Addendum 4

Beaufort EMS

**BEAUFORT EMS
STEEL TANK ROAD SUBSTATION**
BEAUFORT, NORTH CAROLINA

SK-1

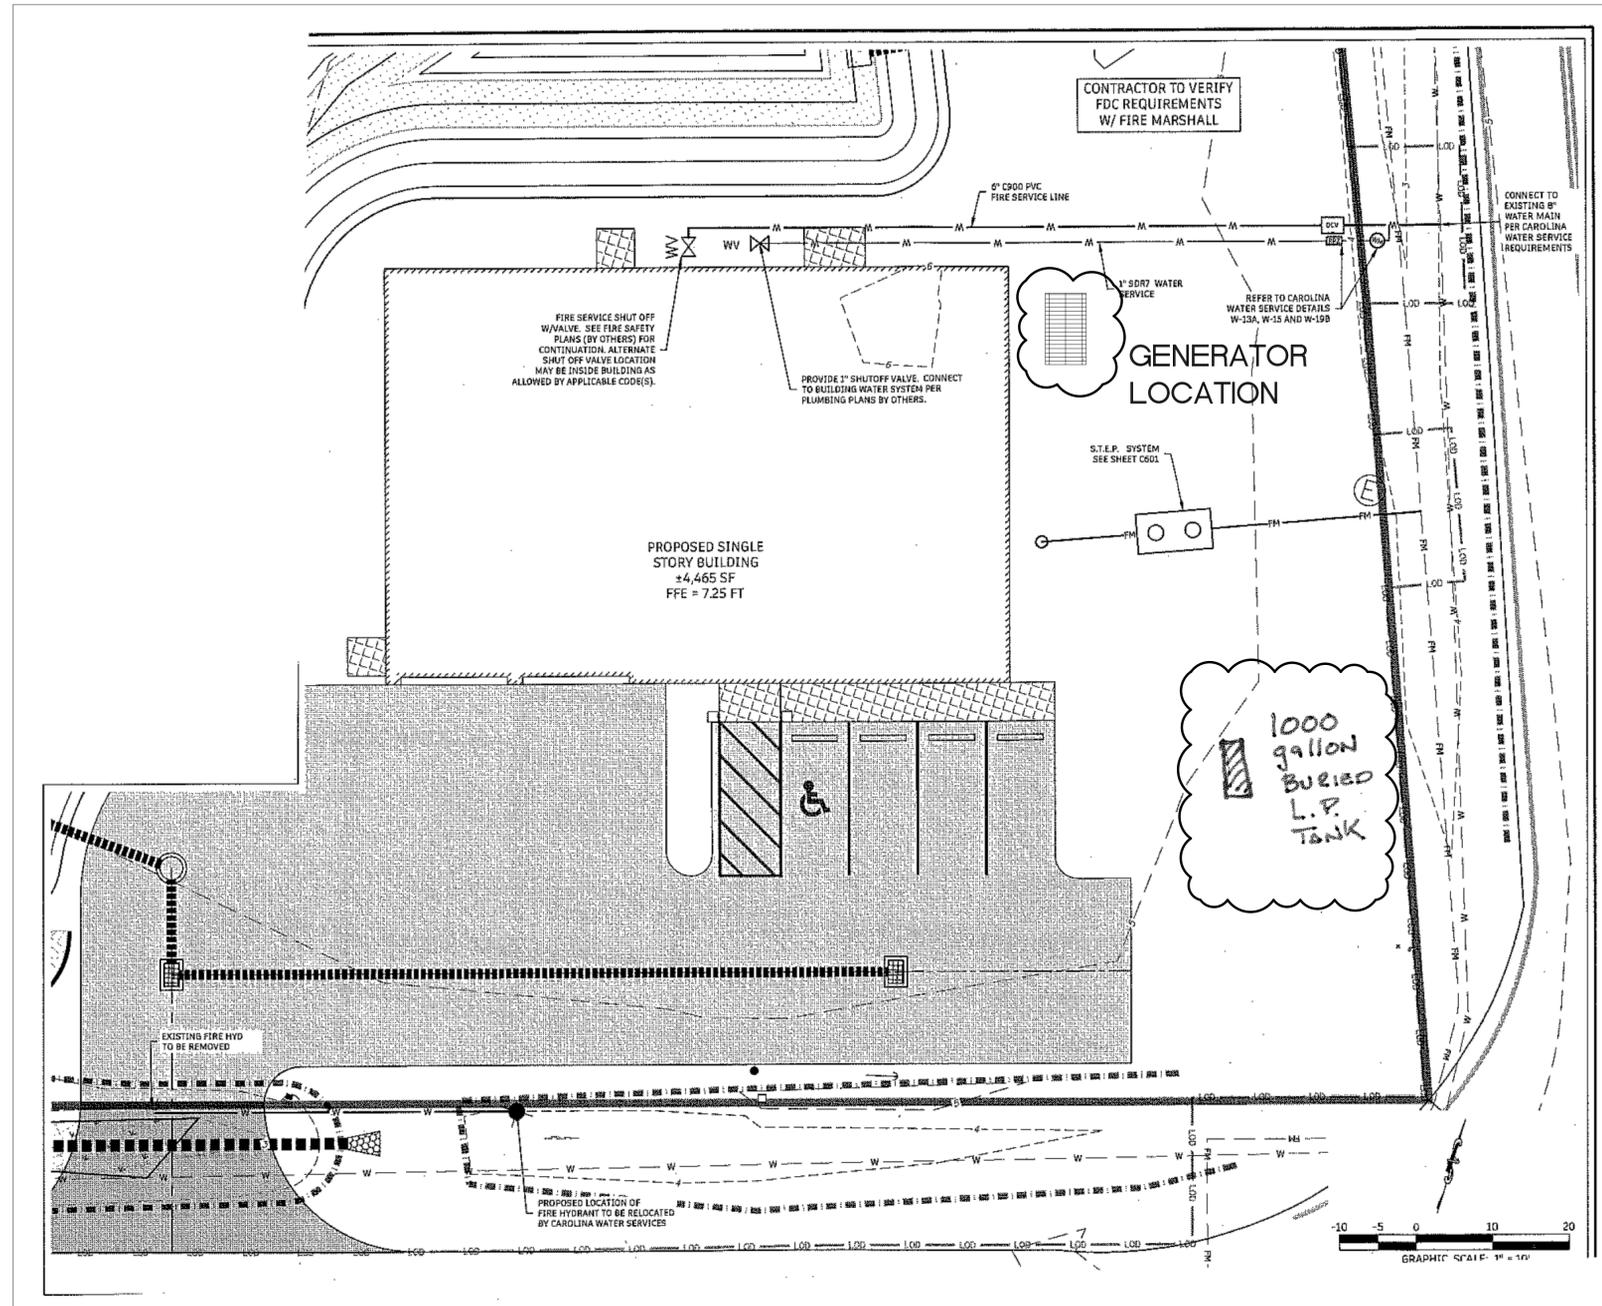
- See SK-1 for generator location.
- Provide a \$25,000.00 allowance for testing.
- Laundry Room 118 clarification: A counter is not required at this time.
